IMPORTANT RECALL INFORMATION #80211

**SUBJECT: RECALL CAMPAIGN #80211
2008 TERRA & FIESTA MOTOR HOME
ENTRY STEP ATTACHMENT CRADLE/SUPPORT**

Recall Bulletin 80211

SUBJECT:
Reinforce
the Entry
Step Cradle

Figure 1

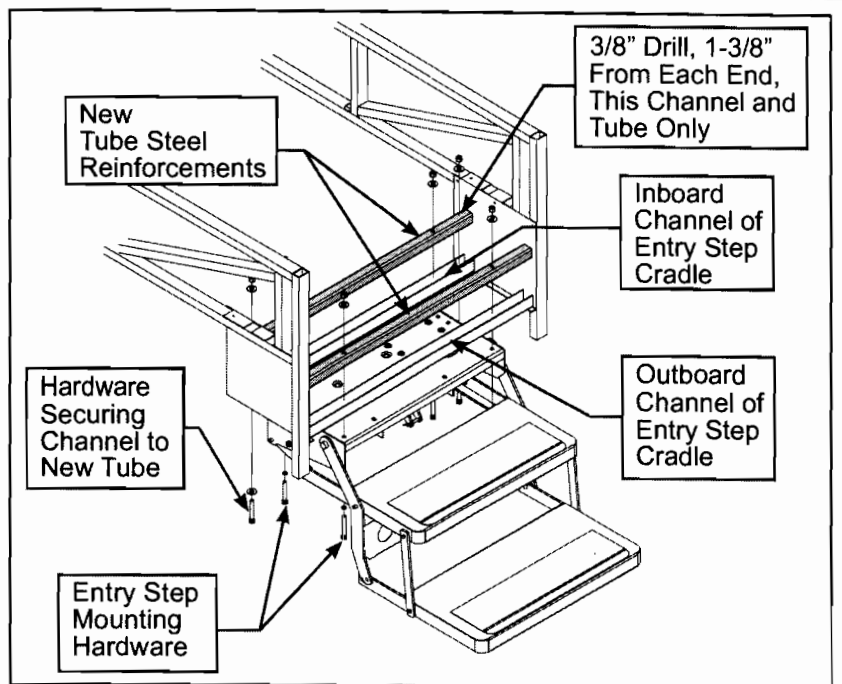
The entry step attachment cradle on certain 2008 Fiesta and Terra motor homes may bend as a result of step usage and insufficient structural material strength.

7. Use an electric drill with a 3/8" twist drill bit, to drill out the threads of the four weld nuts in the entry step cradle that were used to secure the entry step frame. See Figure 1.

8. Place a new 1-1/4" square steel tube inside the top of each of the two step cradle channels with the two 7/8" holes placed down over the top of the existing weld nuts. See Figure 1.

9. Place a split lock washer on each of two 3/8-16 X 2-1/2" bolts. Insert the bolts up through the inboard mounting holes for the entry step frame, through the inboard entry step cradle, and through the new 1-1/4" square steel tube. See Figure 1.

14. Drill a 3/8" hole through the entry step cradle channel continuing up through the new 1-1/4" square steel tube on each end of the inboard entry step cradle channel. See Figures 1 and 2.

15. Place a flat washer on each of two 3/8-16 X 2-1/2" bolts. Install bolts passing up from the bottom of the entry step cradle and through each of the two holes drilled in Step 14. See Figure 1.

12. Torque all four entry step mounting bolts to 25-30 ft-lbs.

Figure 2

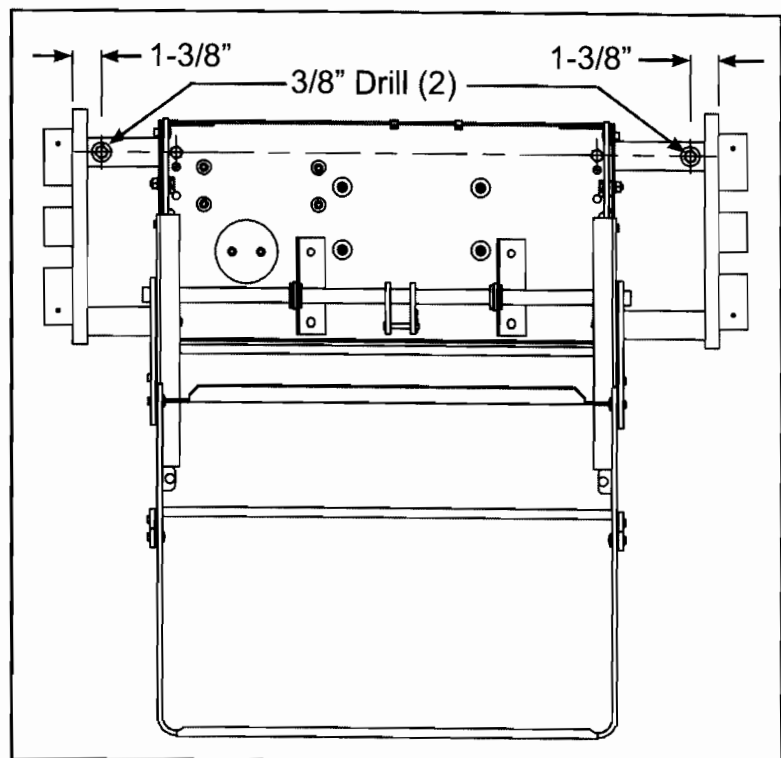
13. Measure and mark 1-3/8" from each end of the inboard entry step cradle channel. See Figure 2.
